Palmerstown SHD Section 146B Response

To An Bord Pleanala	Project number 60556657	Client Randelswood Holdings Ltd.	Subject Section 146B Response
Date 25 th February 2022	Issued by Zachary Cave	Reason for issue Information	Prepared by Zachary Cave

AECOM have been commissioned by Randelswood Holdings Ltd. to prepare a response for further information by An Bord Pleanala (ABP), dated 28th January 2022.

Figure 2.2 – Section 146B Application Site Access Update

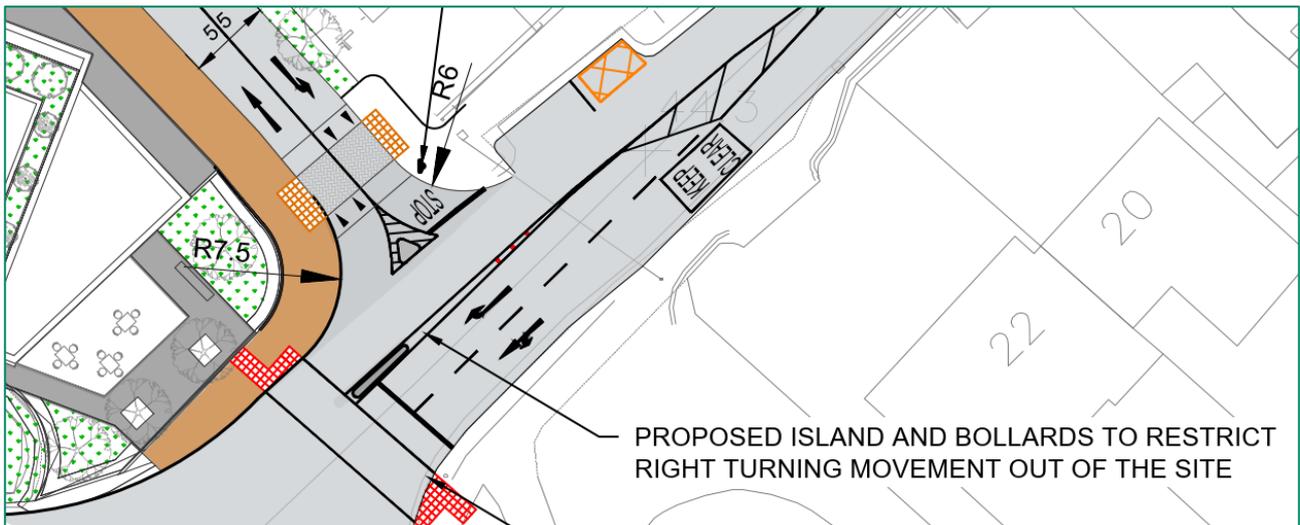
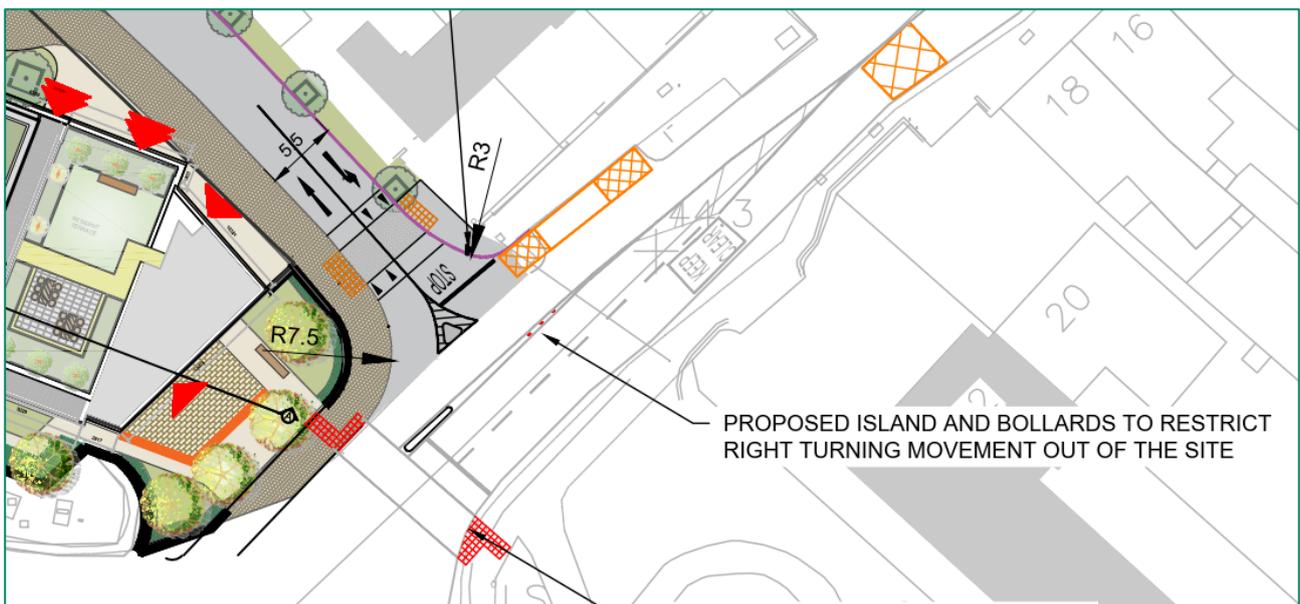
- a) Full specification of the proposed works to the junction at Kennelsfort Road Lower including the sightlines proposed to the north and south of the junction;
- b) An updated Traffic Assessment and or plans detailing the proposed sightlines, having regard to the permitted works at the junction any local or national standards; and
- c) Details of any changes to bicycle and car parking, including a breakdown of the permitted strategy in both ABP-307092-20 and as amended by ABP-309899-21.

The updates to the site access junction consist of widening the access for vehicles egressing from the site, setting the raised pedestrian crossing back into the site and removing a section of path to facilitate turning movements. These changes were required as to ensure that a refuse vehicle can exit the site safely without encroaching on the pedestrian footway at this location. The permitted entrance and the updated site access are shown in Figure 2.1 and Figure 2.2, respectively.
